工程指示 / 要求簡箋(E.I.)

工程指示編號：EI / 0151 / 19

工程名稱：觀塘裕民坊

工程項目：幕牆 趟門拆圖問題回覆(2019.1.22 問題)

1 TYPICAL TRANSOM DETAIL  
6004 CURTAIN WALL

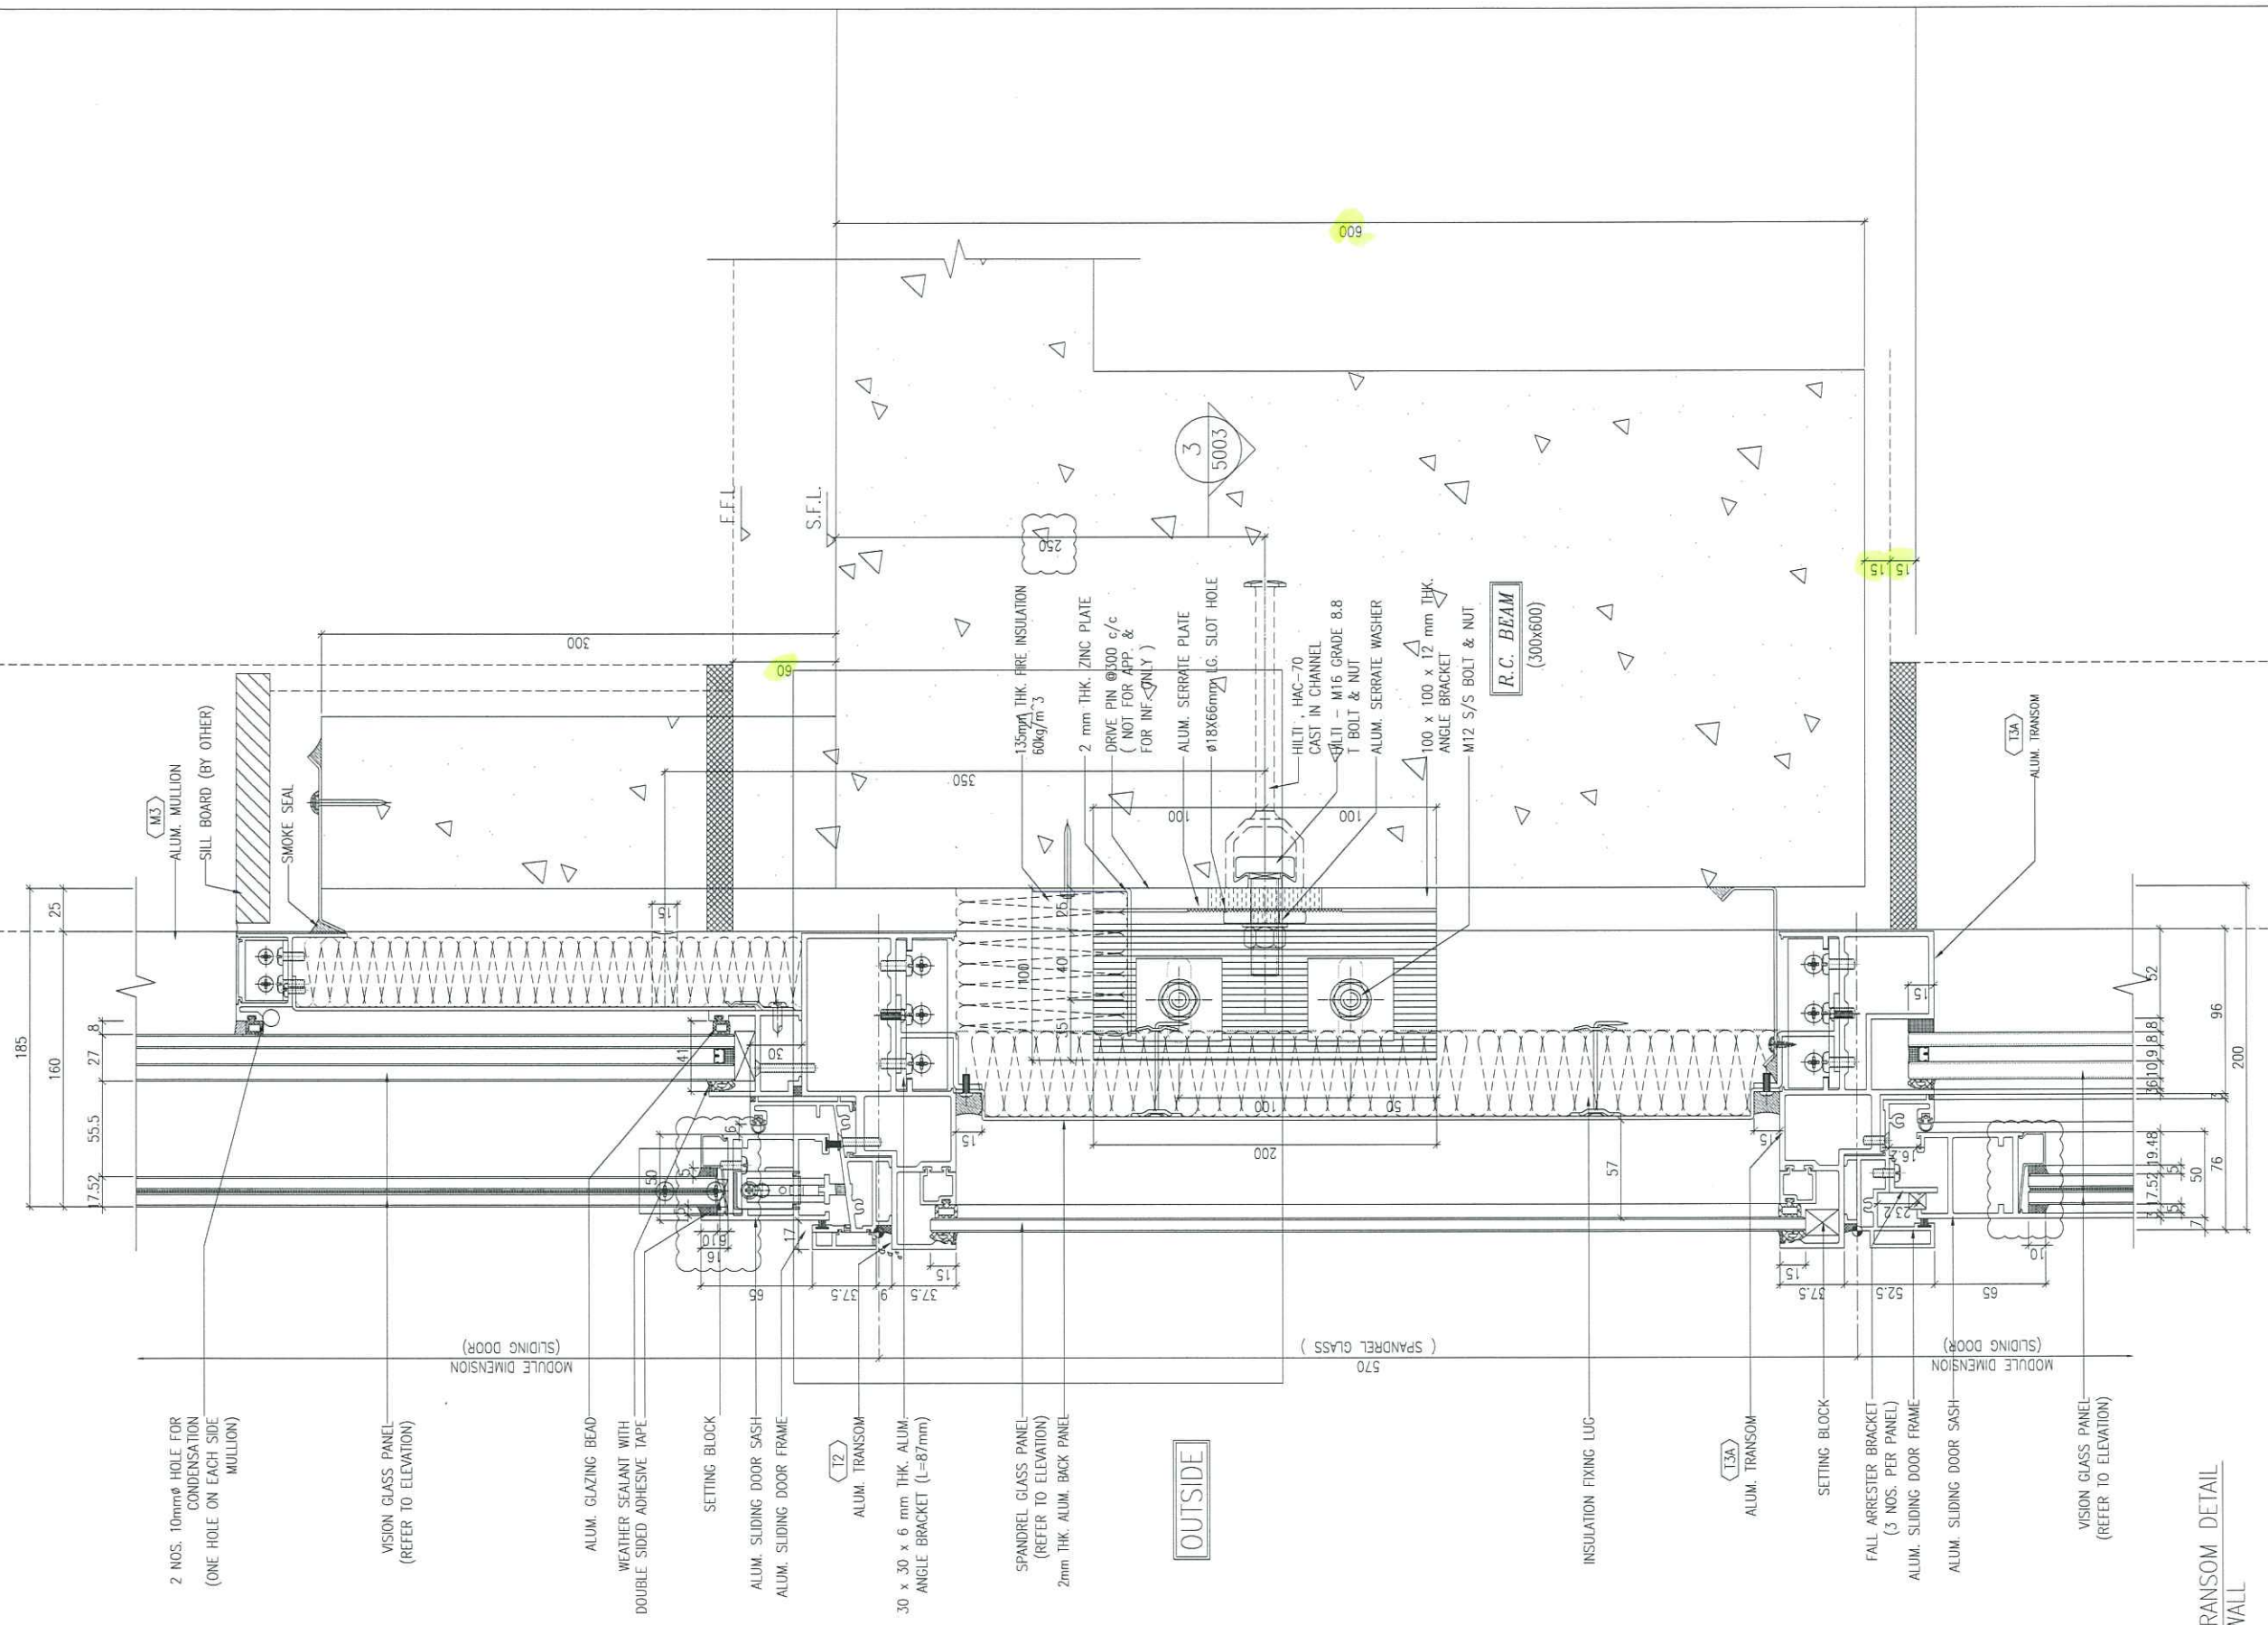
回覆有關 2019.1.22 趟門拆圖問題，

**A 版:** 修改#7 回答，確定為 2445mm 長

**原版:** 1) #1-3 再回覆(只影響 TICW/G-1)

2) #4 分防墮角及防盜角，防墮角廠裝在頂橫框，防盜角地盤安裝門玉後裝

3) #5,6，按圖標示 去水孔距為料邊入 100

4) #7 趟門室內企身扣蓋，料長 2460- 2445 (頂底用膠封口)

5) #8 手柄中至地台完成面高度為 1000 (跟 FD 門)
